REVISION #1 09/16/2024
REVISED SHEETS: EC1-EC3, U1-U3, U6, U7
REVISION #2 02/28/2025
REVISED SHEETS: EC1, PD4, P4, U4, S1, S2, S3, S6 - new sheet, X8, X9
REVISION #3 04/25/2025
REVISED SHEETS: PD3, P3, X5, X6
REVISION #4 04/28/2025
EVISED SHEETS: G11, G12, G14 - new sheet, PD3, P3, P4, P6, U3, U6, X4, X5

PLAN OF PROPOSED IMPROVEMENT

KNUTSON DRIVE AND GREEN AVENUE ASSESSMENT DISTRICT - 2024

CITY PROJECT NO. 13812
CONTRACT NO. 8635

CROSS SECTION & QUANTITIES

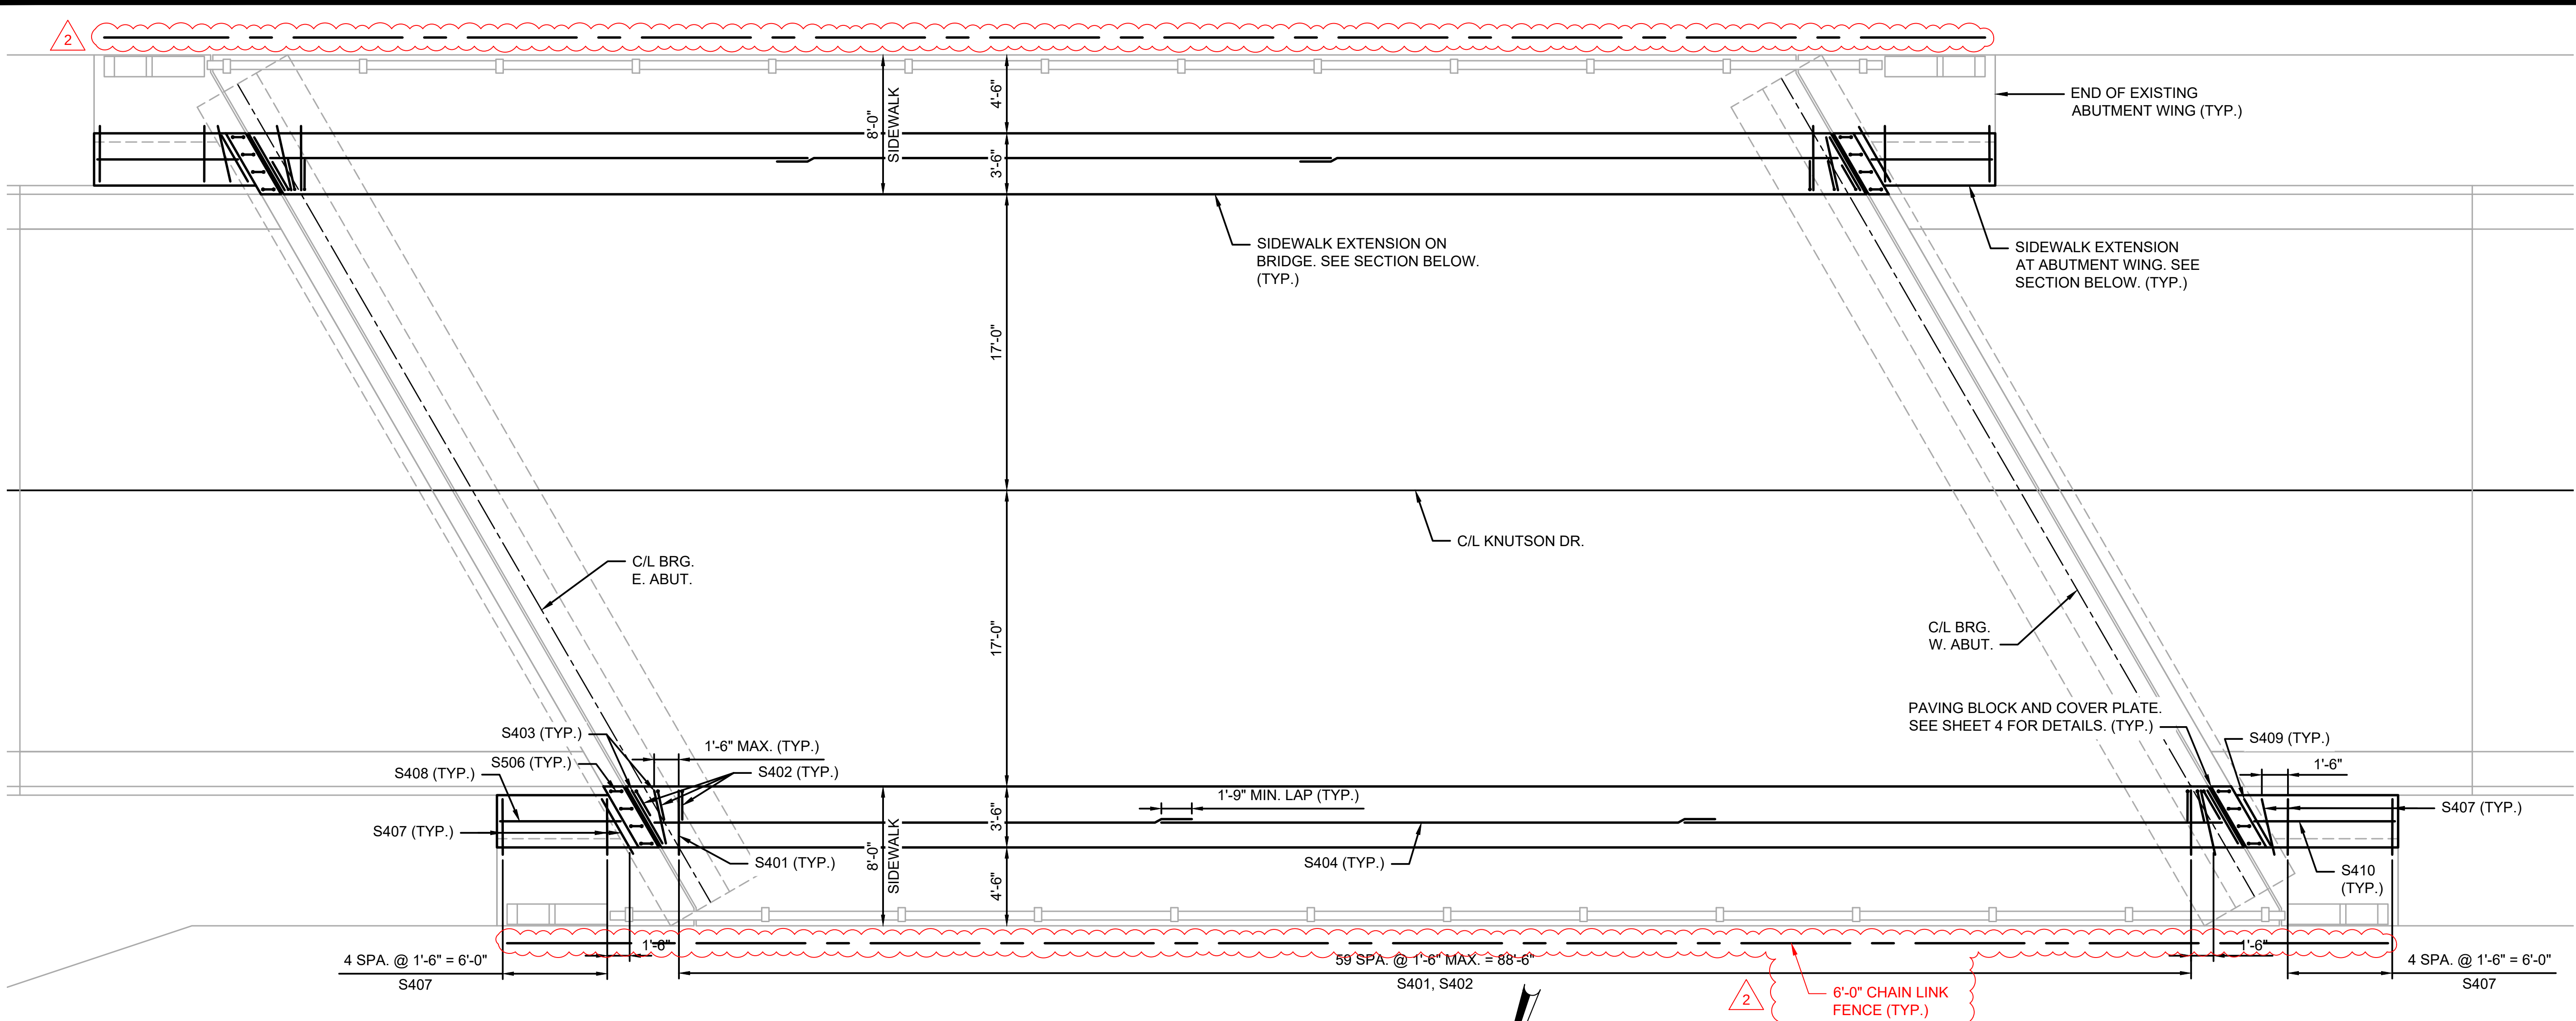
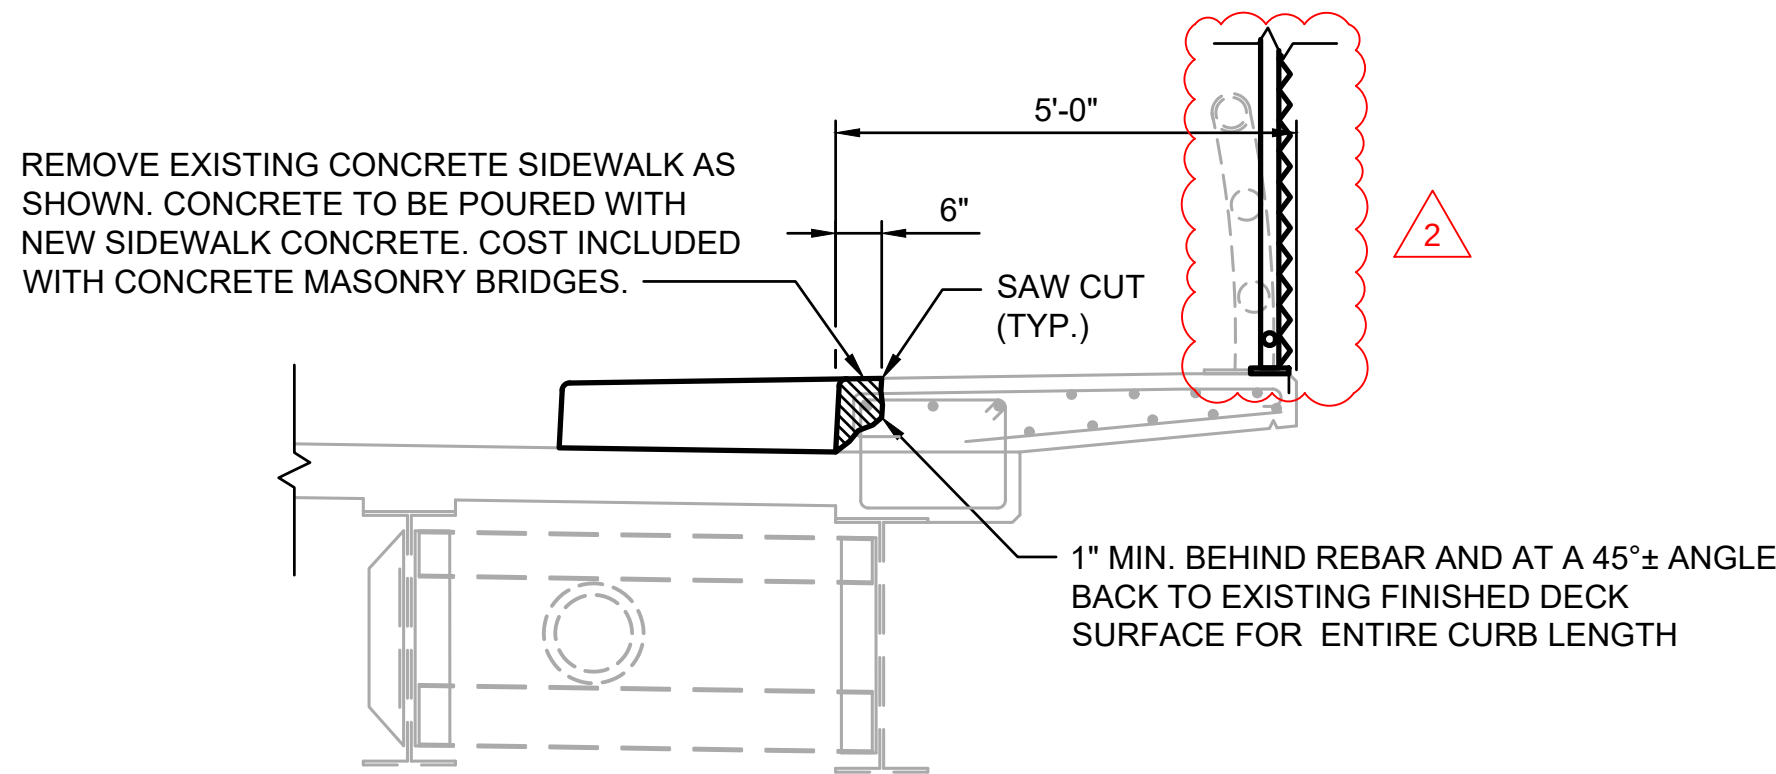
DATE:	2/7/2025
REVISIONS	ADD 6'-0" FENCE
NO.	2

SUPERSTRUCTURE PLAN & DETAILS

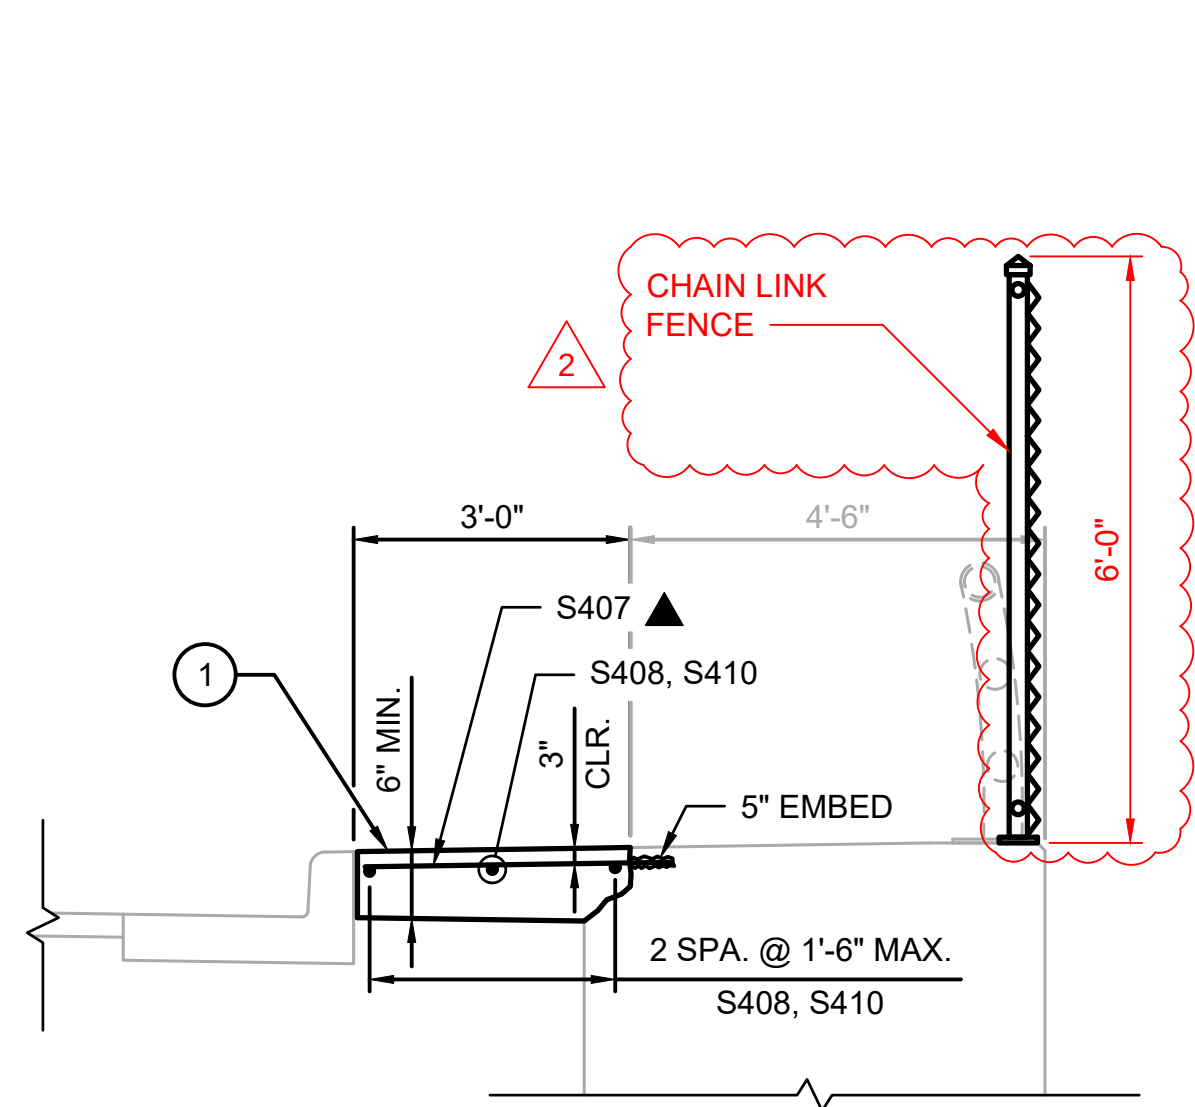
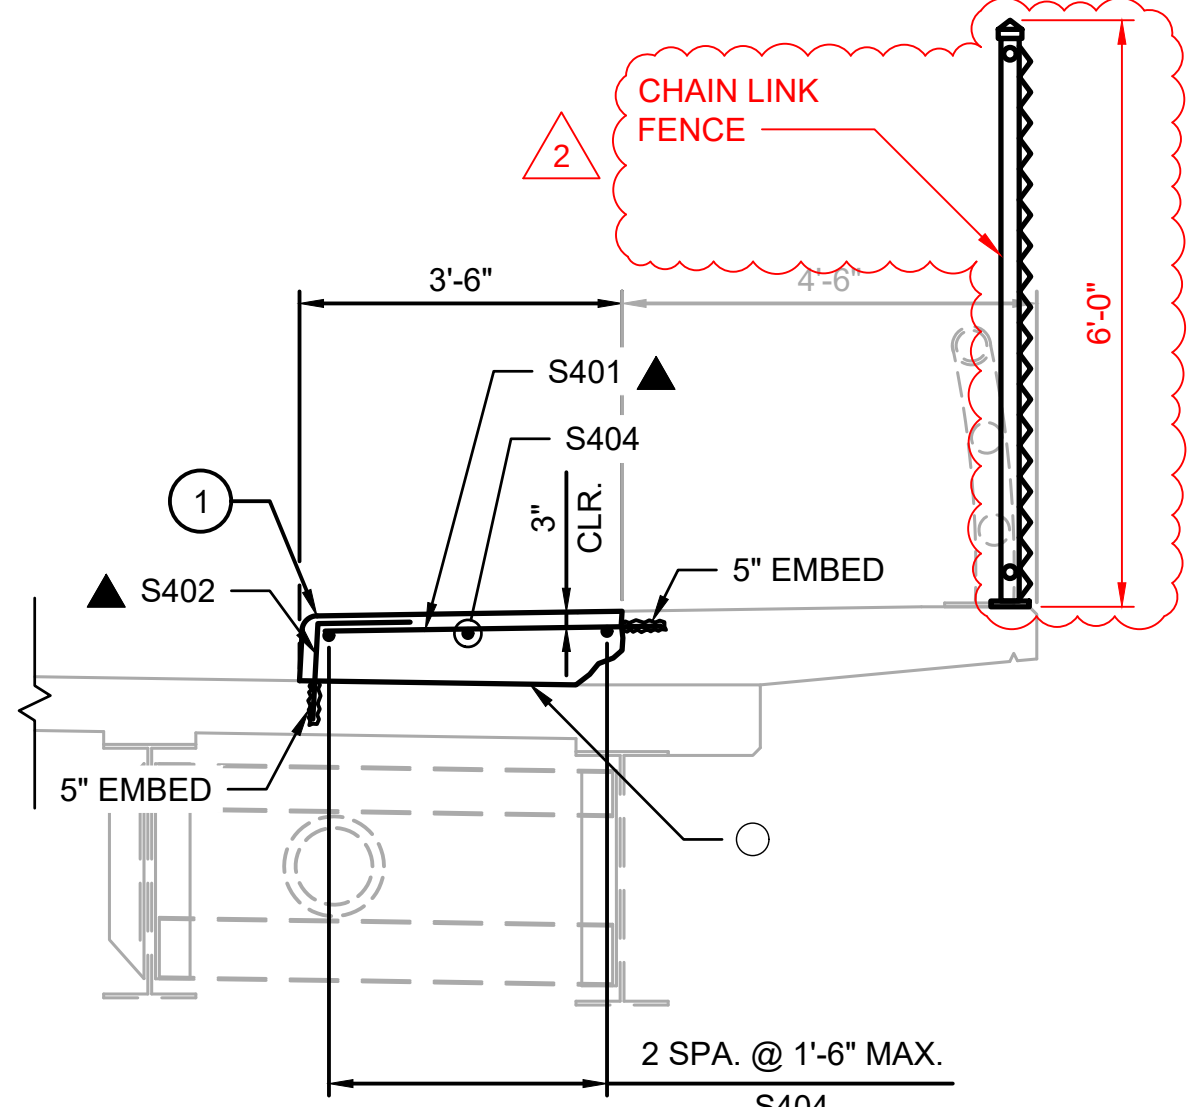
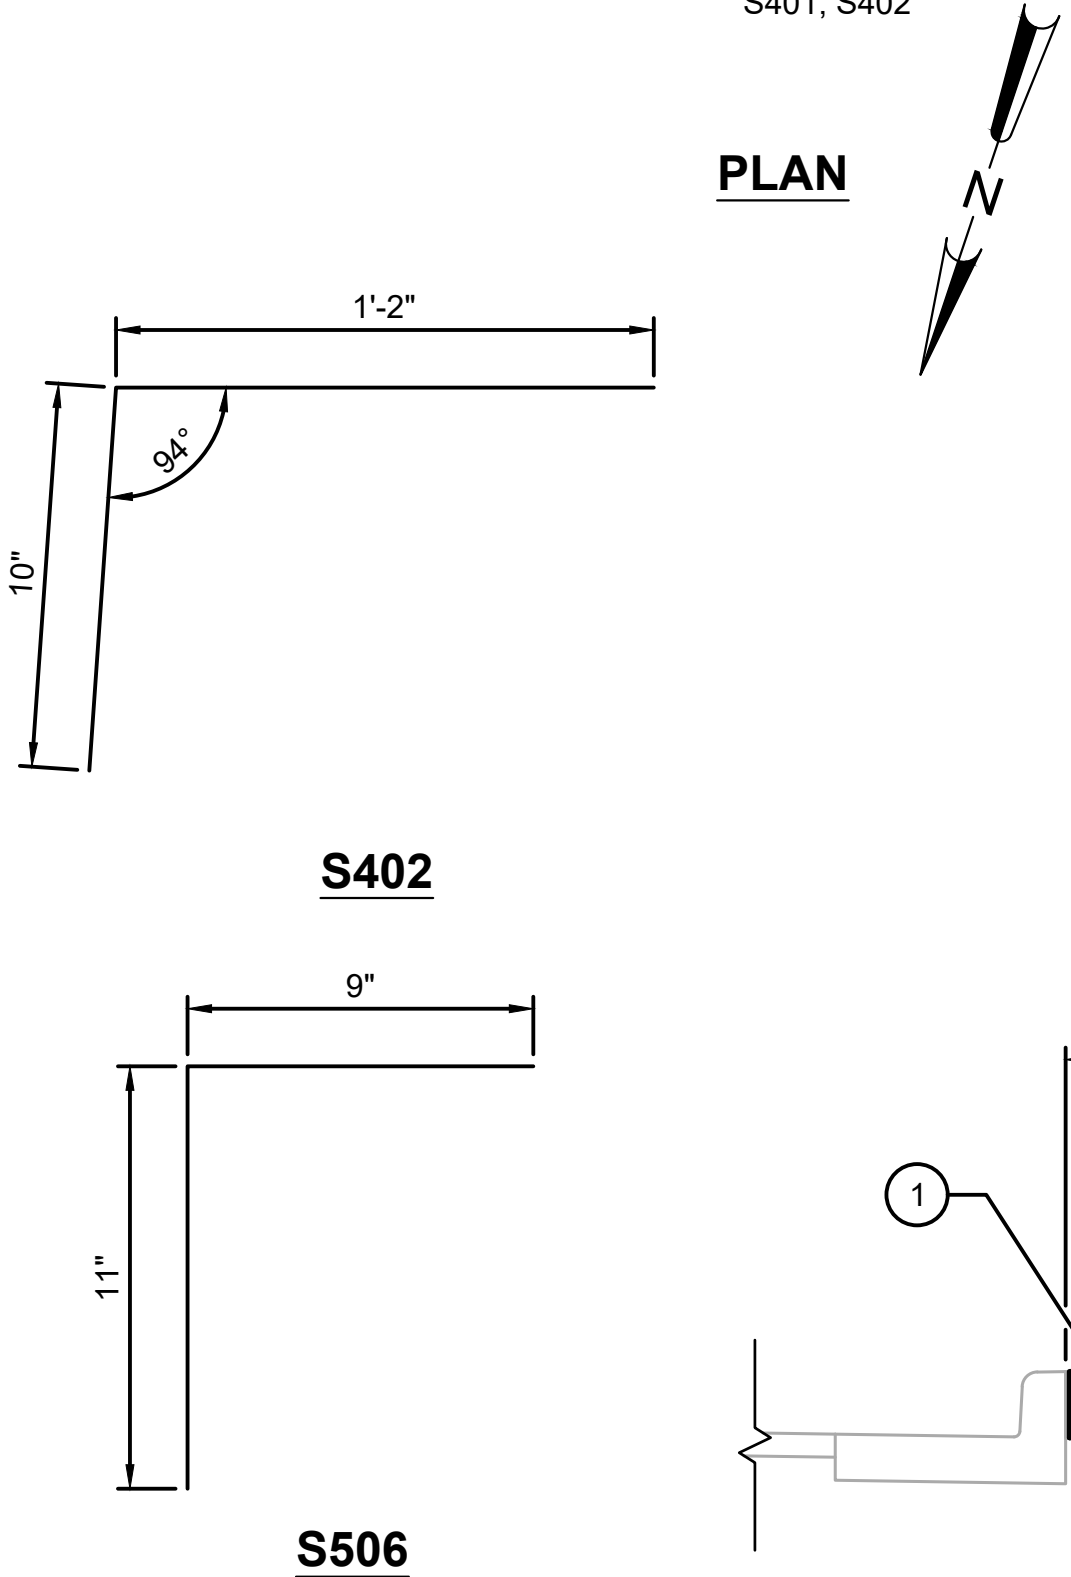
NO.	REVISIONS	DATE
2	ADD 6'-0" FENCE	2/7/2025
